Proposed TDECQ Change in Clause 138.8.5*

Frank Chang, Inphi; Hai-Feng Liu, Intel

IEEE P802.3cd Interim Meeting, Charlotte, NC, September 2017

One serious problem for directly modulated lasers: Amplitude-dependent skews with PAM4 eyes

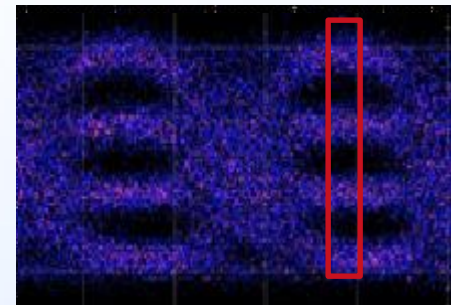
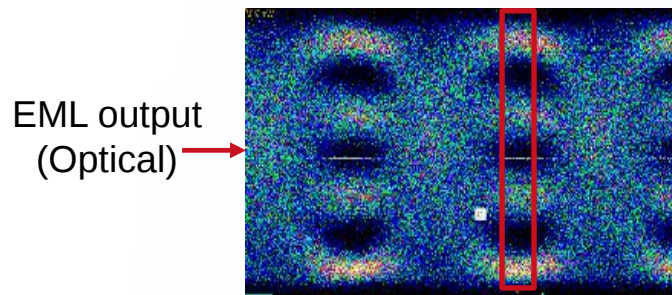
- Laser characteristics with direct modulation cause seriously skewed waveform.
 - Such non-linearity compensation can be readily implemented in PAM4 RX DSP and/or driver devices.
 - However, this is not defined in current TDECQ methodology possibly resulting in unrealistic & larger TDECQ values.

Targeted samples on PAM-4 eye diagram.

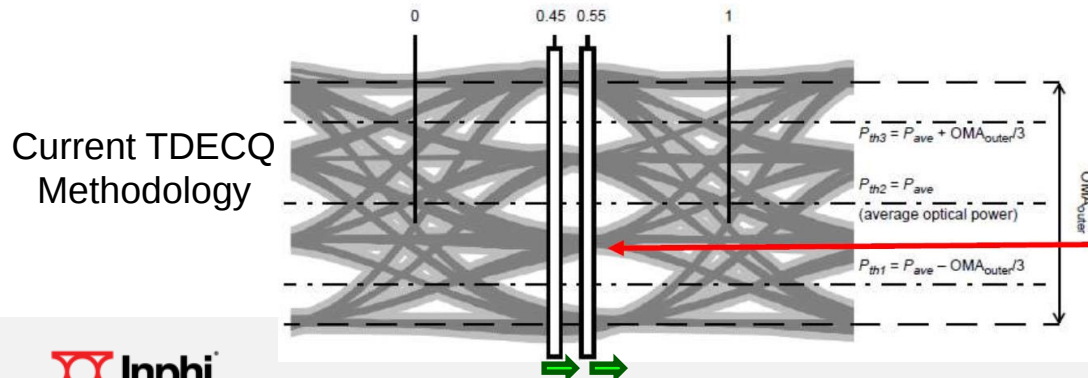
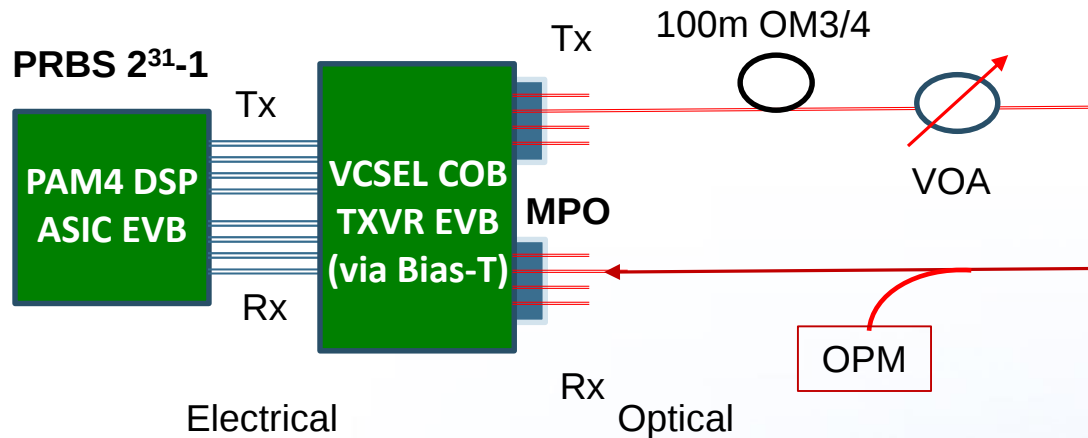
Note:
The proposal to allow the overall sampling timing to move may not align skews independently between 3 PAM4 eyes

VCSEL Transmitter (P802.3cd D2.1, 5 T-spaced at 11.2GHz)

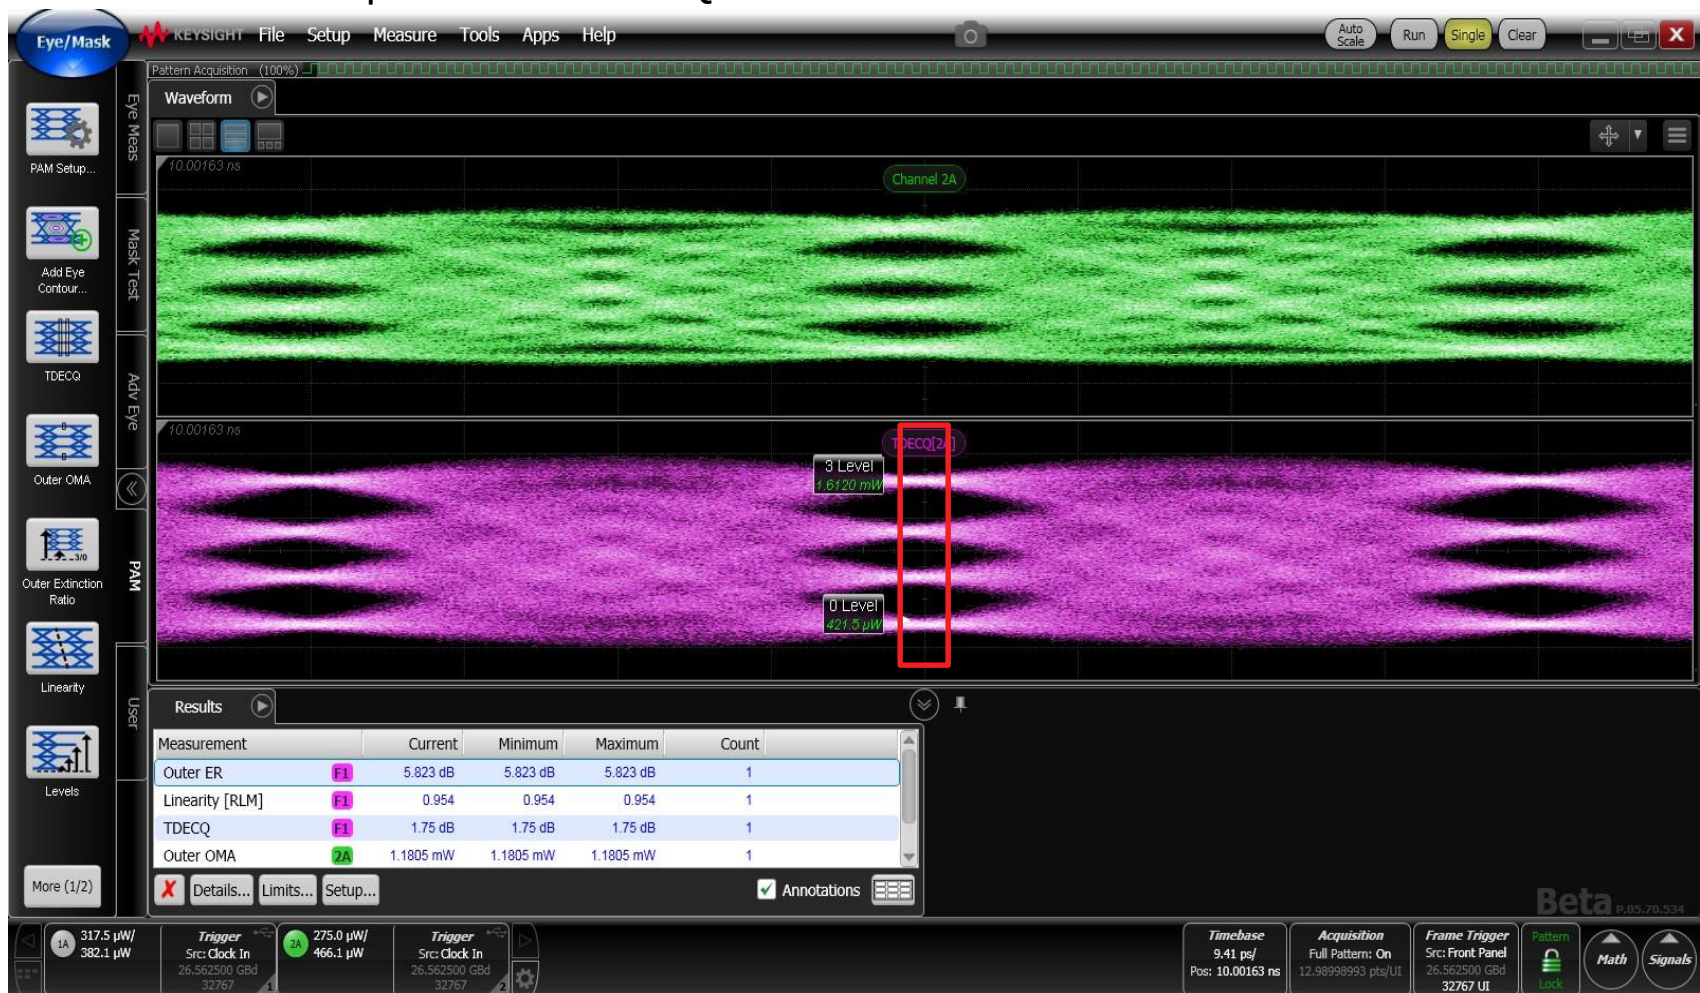
- Use PRBS15 pattern as SSPRQ is not available
